July 28, 2014
RSM-072814-085

Subject: Central and Eastern United States Seismic Source Characterization (CEUS SSC) for Nuclear Facilities, EPRI report number 1021097

Error Description

Figure 4.2.4-2
Seismotectonic zones shown in the case where the Rough Creek Graben is not part of the Reelfoot Rift (RR), and the Paleozoic Extended Zone is narrow (PEZ-N)

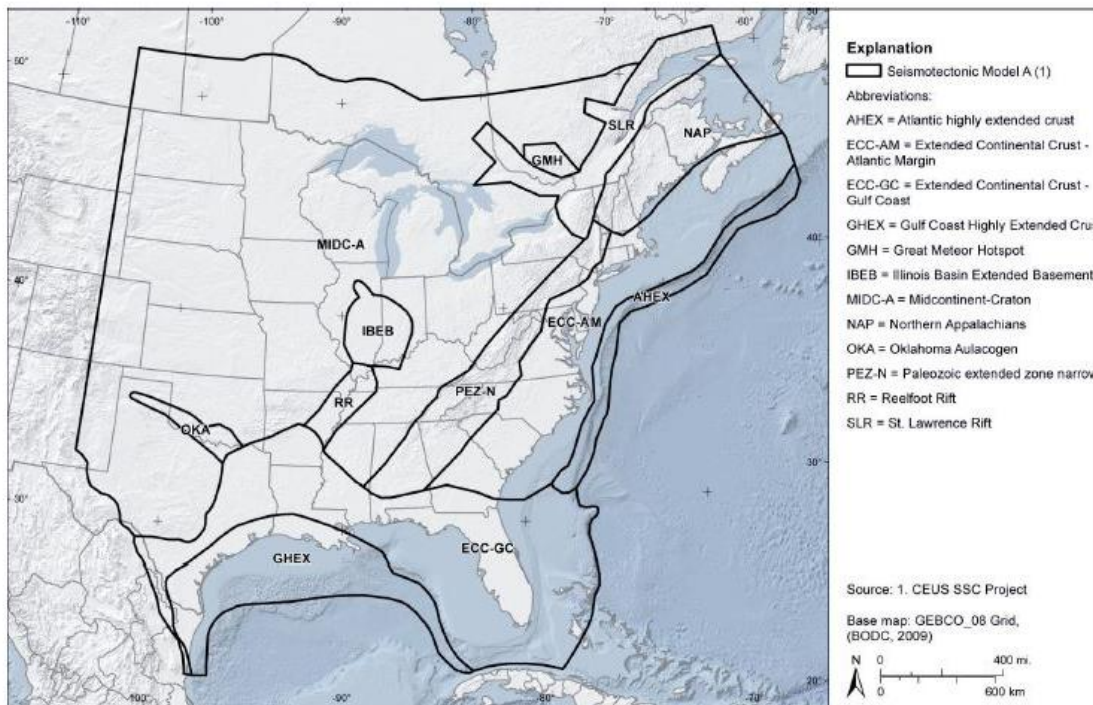
The specific error is that the Maximum Magnitude (Mmax) distributions for three of the CEUS SSC seismotectonic model zones listed in Table H-4-4 of the CEUS SSC report are incorrect. The affected zones are PEZ-N, PEZ-W, and IBEB. The published and corrected Mmax values are provided in the table below.

Figures 4.2.4-2 and 4.2.4-3 in the CEUS SSC report show the seismotectonic zones and are reproduced below. Figure 4.2.4-2 includes the PEZ-N and IBEB zones and Figure 4.2.4-3 includes the PEZ-W and IBEB zones.

PEZ-N		PEZ-W		IBEB	
CEUS SSC Report	Corrected Value	CEUS SSC Report	Corrected Value	CEUS SSC Report	Corrected Value
5.9	6.0	5.9	6.0	6.5	6.4
6.4	6.5	6.4	6.4	6.9	6.7
6.8	6.9	6.8	6.9	7.4	7.0
7.2	7.4	7.2	7.4	7.8	7.3
7.9	8.0	7.9	8.0	8.1	7.9
